New 1-Story Office Building

Design Review Revisions

From: [Erik Hagen](#)
To: [Mariia Antonova](#)
Subject: Re: DSRFY2026-0004
Date: Tuesday, March 10, 2026 2:39:16 AM
Attachments: [image001.png](#)
[image002.png](#)
[image003.png](#)
[image004.png](#)
[image005.png](#)
[image006.png](#)
[6655 Glenwood Design Review Drawing Set.pdf](#)

G1.2 New Site Plan

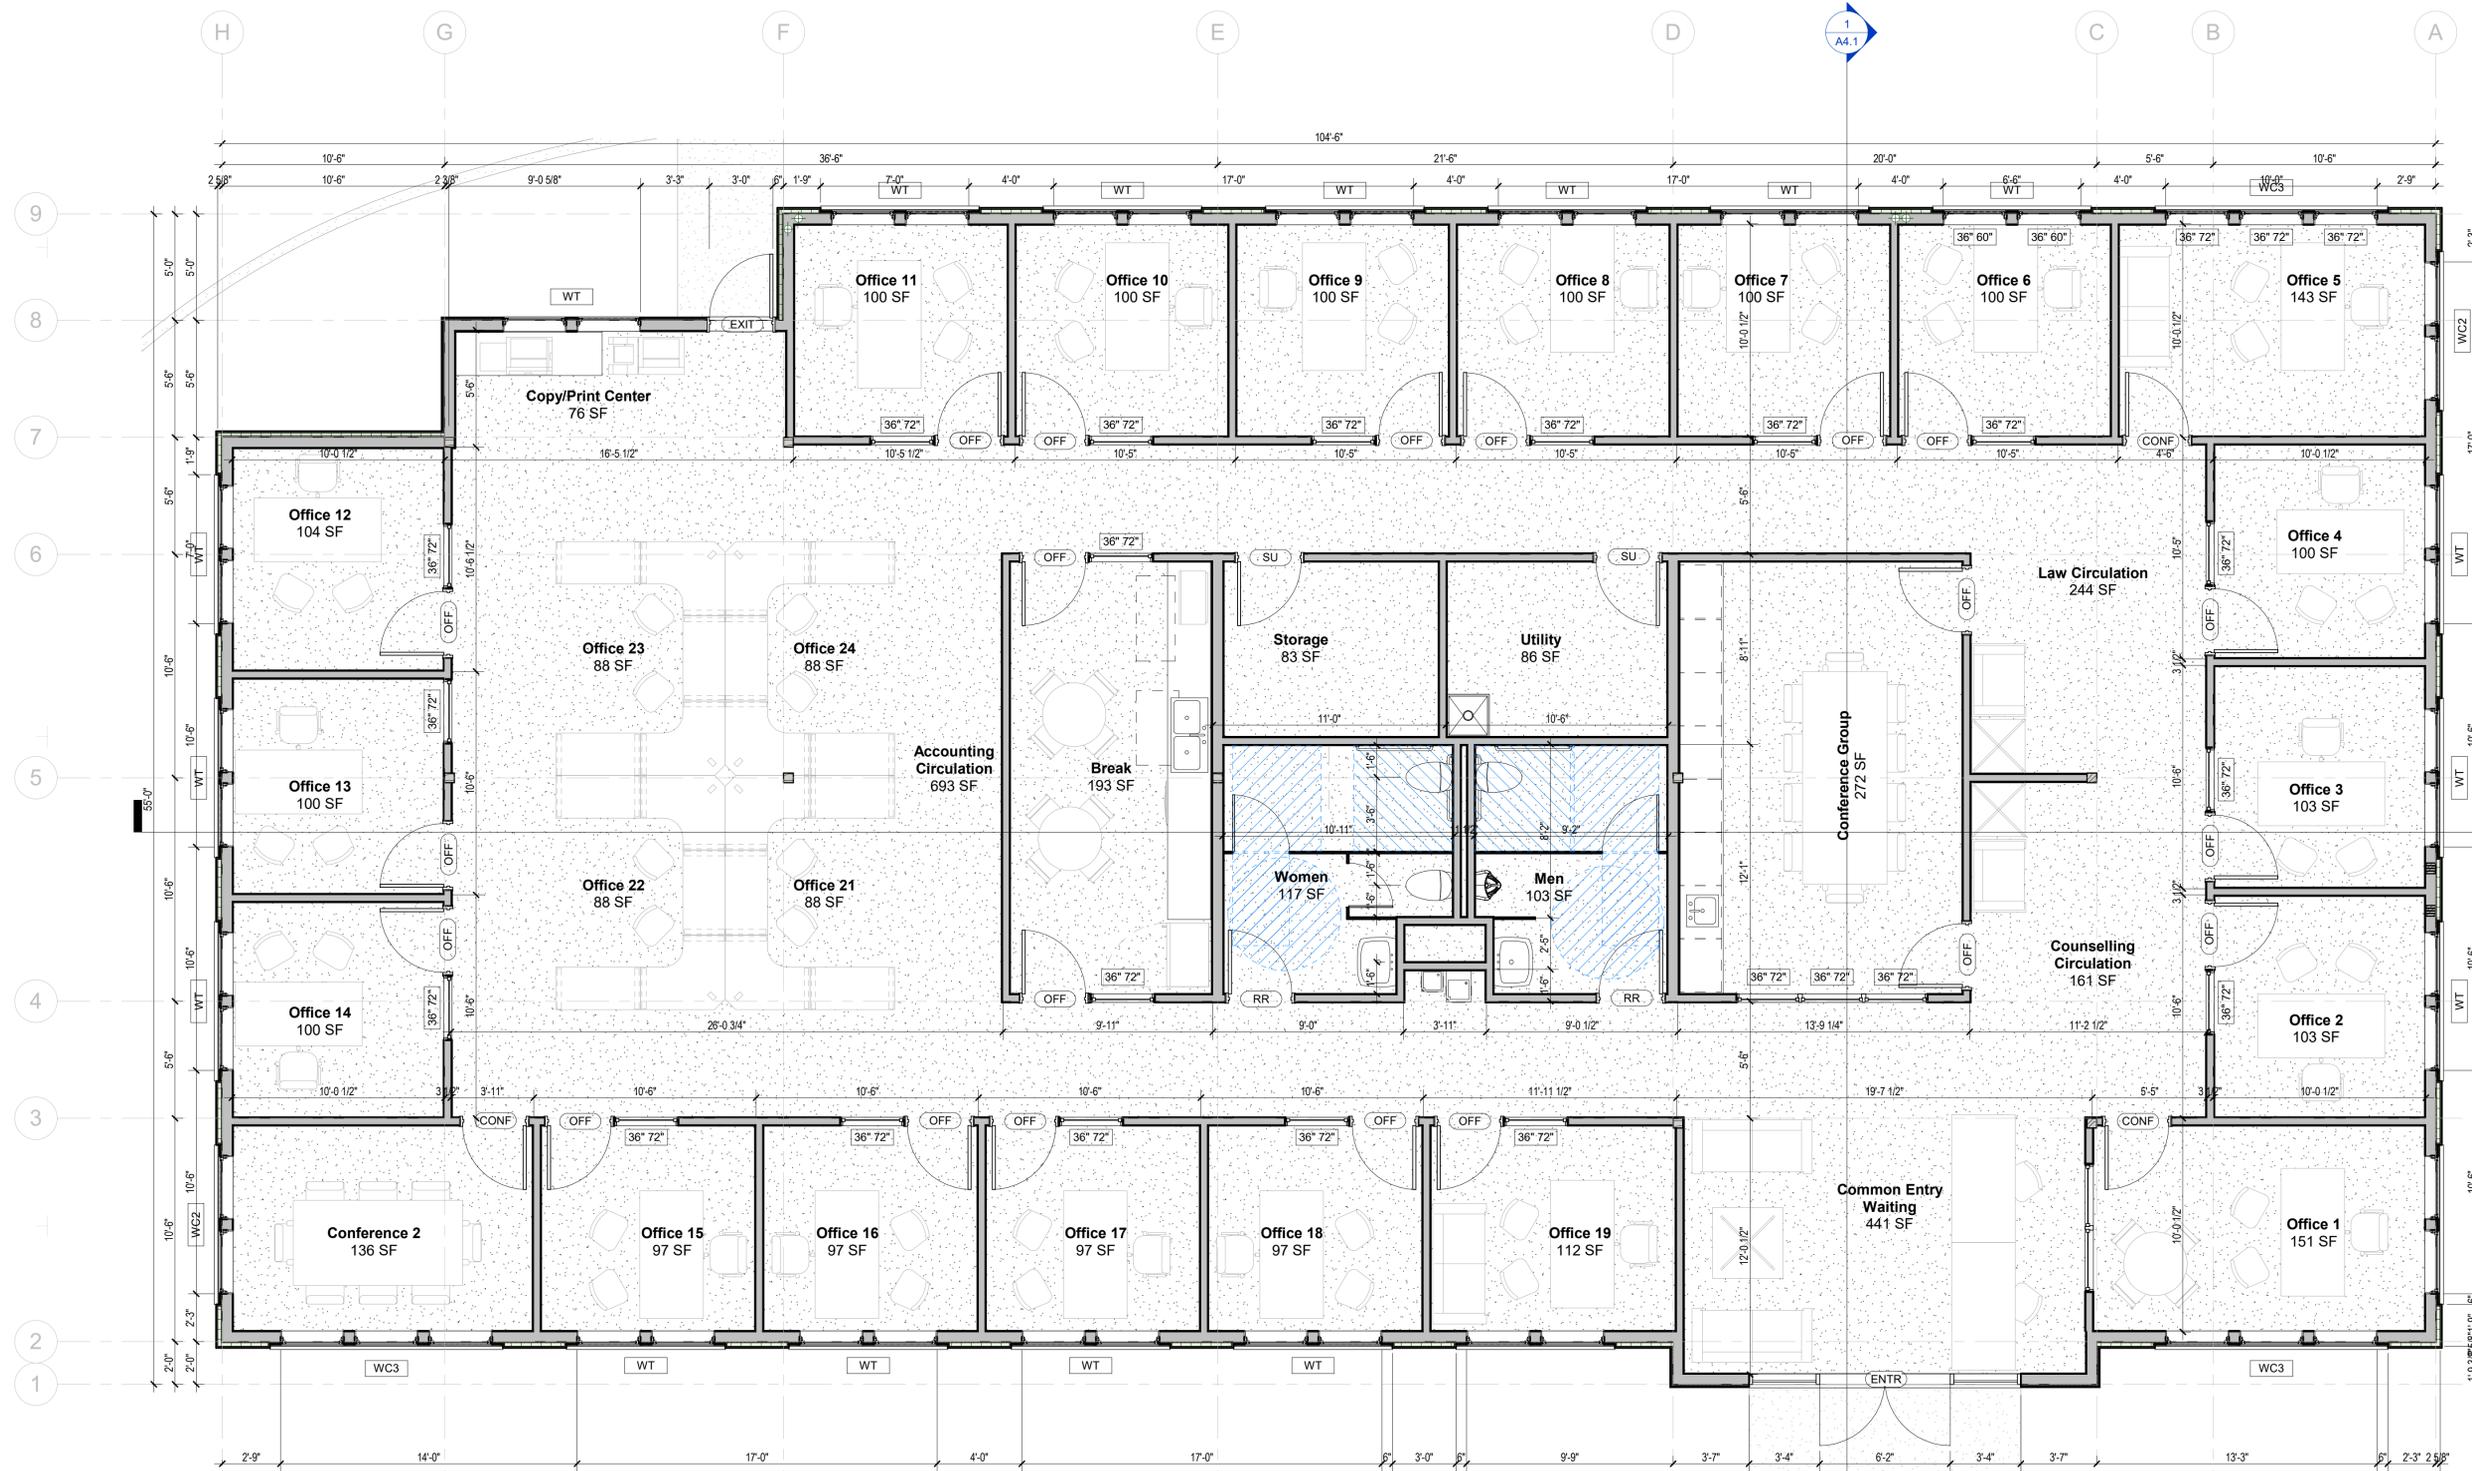
1. Mr. Ilir Nina has provided a new Property Owner Permission Form as requested, in person @ City Hall on 1/28/2026.
2. The new dumpster enclosure at the south end of the property for Swig will be built to meet Republic Services 12'x10' min. for a 3-8 yd dumpster/ Providing at least 2' of clearance all around. The approach to remain as is existing.

3. We have added more bushes for screening around the electric transformers and telephone pedestals.
4. Facade Percentages of openings and materials have been added to the elevations. The percentages are relatively the same for each elevation.

5. A new pedestrian pathway will be constructed from the Glenwood public right of way sidewalk, across the parking lot. A new Accessible curb ramp will be installed along with a crosswalk striping. A new planter will be installed within the used parking stall to separate parking from walking.

7. Plaza Seating for 100 has been added to the plaza in an assortment of tables & chairs, planter walls, picnic tables.
8. There are 3 double-head site lighting standards existing for security lighting.

10. 4 trash cans have been spread throughout the plaza.
11. The existing parking may have stripes that are 18'-19'. But the drive aisle is well over 22', allowing the parking stalls to well exceed the 20' dimension. It is common for parking striping to be shorter than the space allotted for the parking stall. Plus, the side is 6'-6" wide, allowing for an overhang and still provide 4'-6"

- min. of passage clearance.
12. We are required to provide 6 bike parking stalls. Each inverted U bike rack has room for 2 bikes ea. We are providing 4 racks for a total of 8 bikes.
 13. The existing drives around our building lot are 30' on the west & south sides, 24' on the east side, and 32' on the north side.
 14. Pedestrian Accessibility exists around the development. We are proposing a direct Accessible Pedestrian path of travel from the right of way to the main entrance of our building.
 15. Master sign TBD. There is an existing monument sign located at the main entry drive from Glenwood. It is assumed that we will be able to add into that sign. Or otherwise modify it.

A3.1
Exterior Elevations
East & North

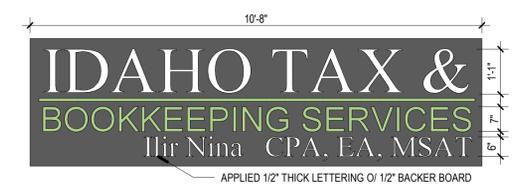
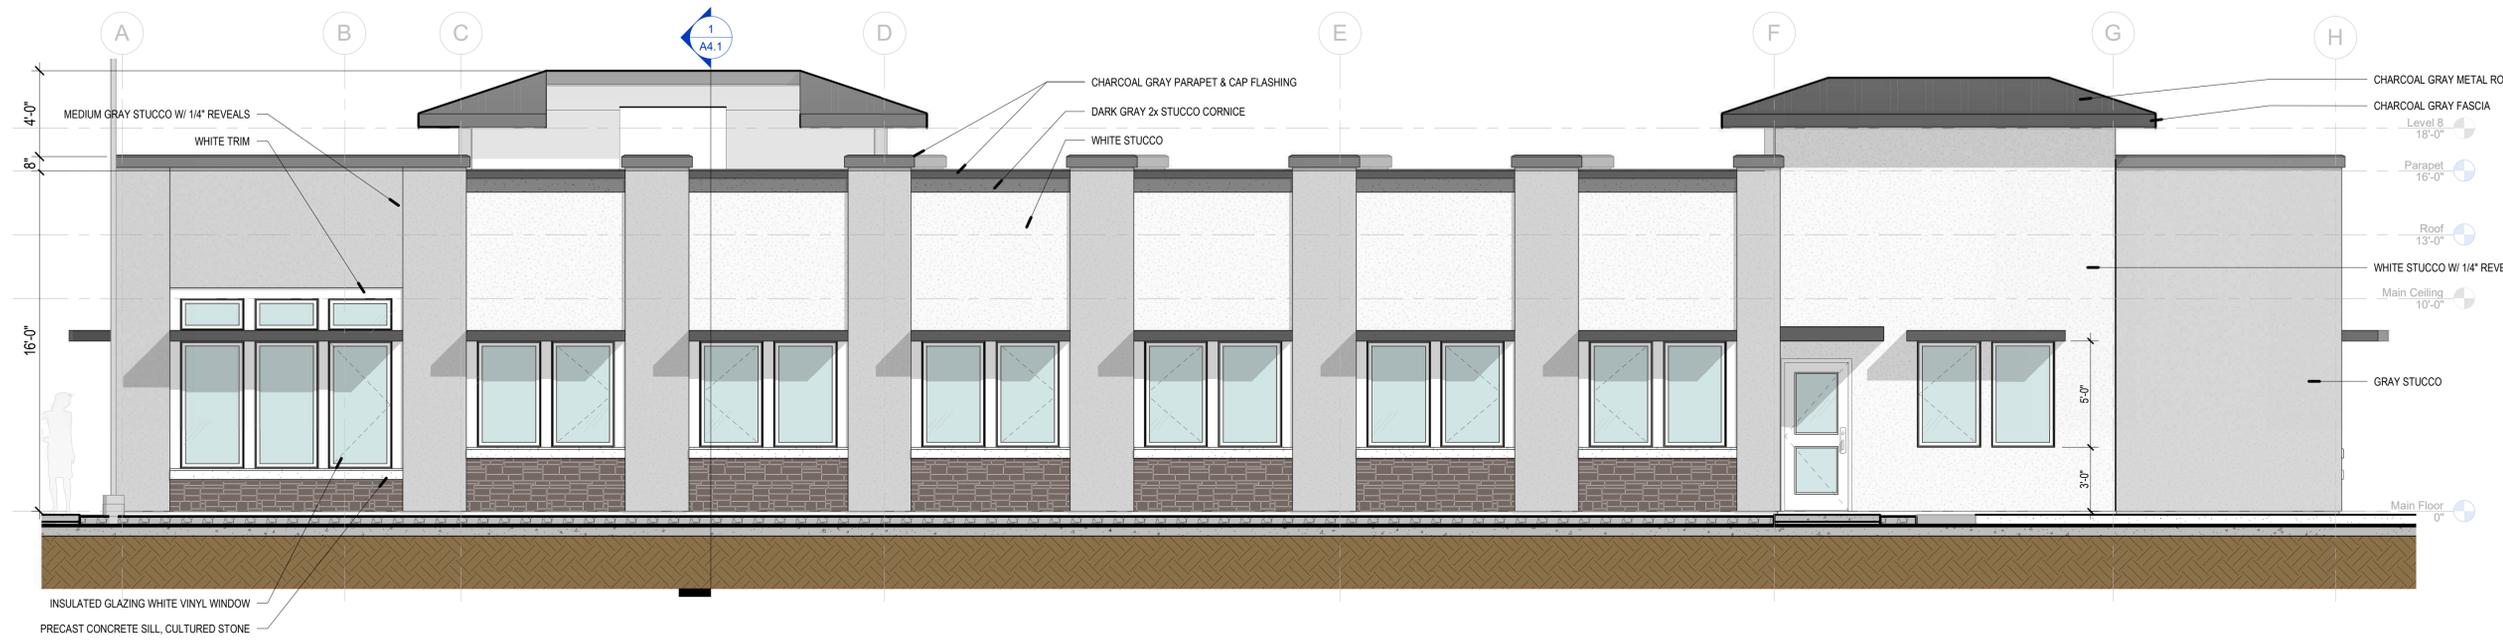
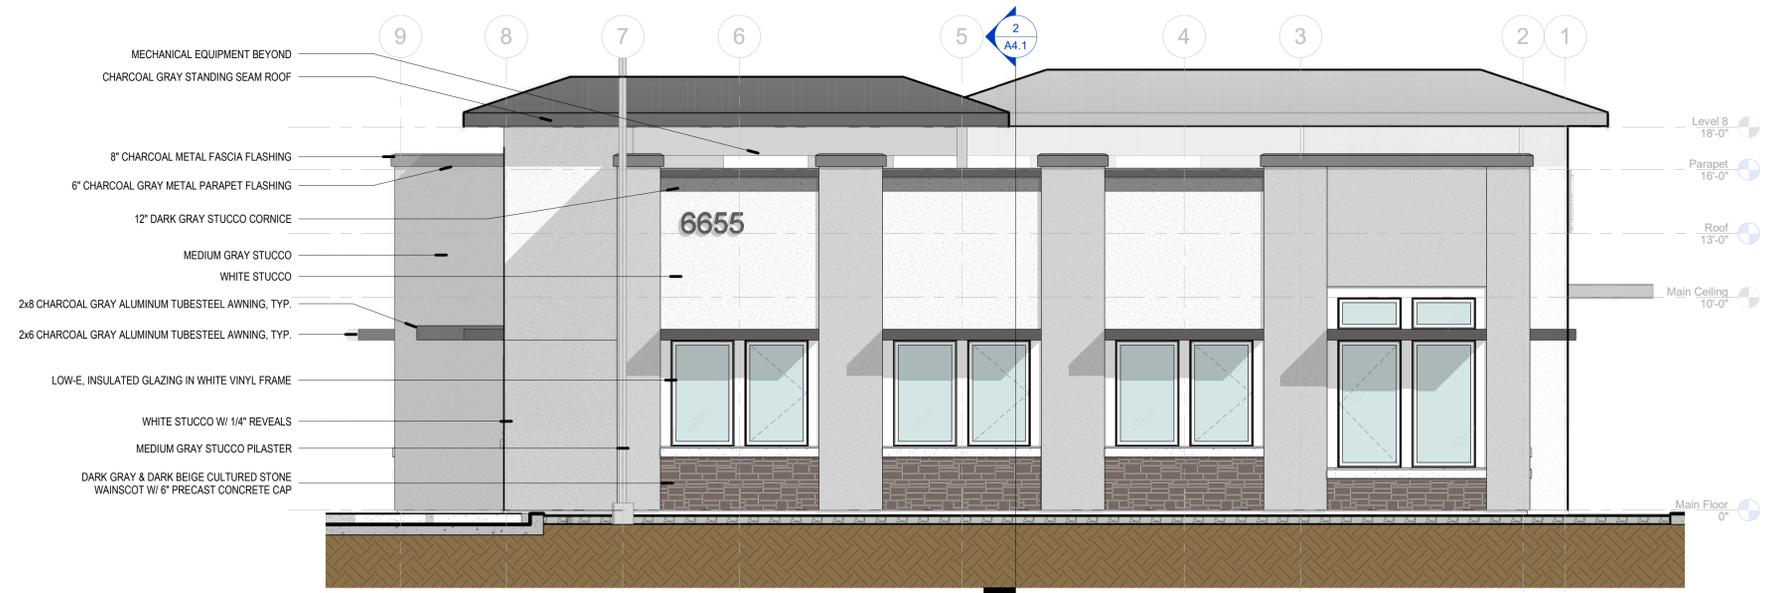
6. The massing and facade of the building has been articulated into separate masses: pilasters between the windows, and a larger boxed out mass at the corners where we plan to have larger windows and a bigger awning. The pilasters are to extend above the main parapet to provide further articulation along the roof parapet. The size and stepping of the parapet and pilaster caps have been increased in size with an added cornice piece to provide a more ornate entablature.
Sticking with the same material palette as the rest of Rivers Edge, we have changed all the fiber cement planks and panels to stucco. And changed the metal wainscot base under the windows to cultured stone.
The colors are a contrast of warm white & medium gray stucco with charcoal gray metal coping, and aluminum awnings. The main accent color to be a bright white stucco. With secondary touches of orangey-beige brown in the dark gray cultured stone bases. The medium gray stucco is intended to be a warm gray. The earth tones are in line with the other buildings in the development.

Facade Percentages:
Glass 32%
White Stucco 29%
Gray Stucco 31%
Cultured Stone 8%
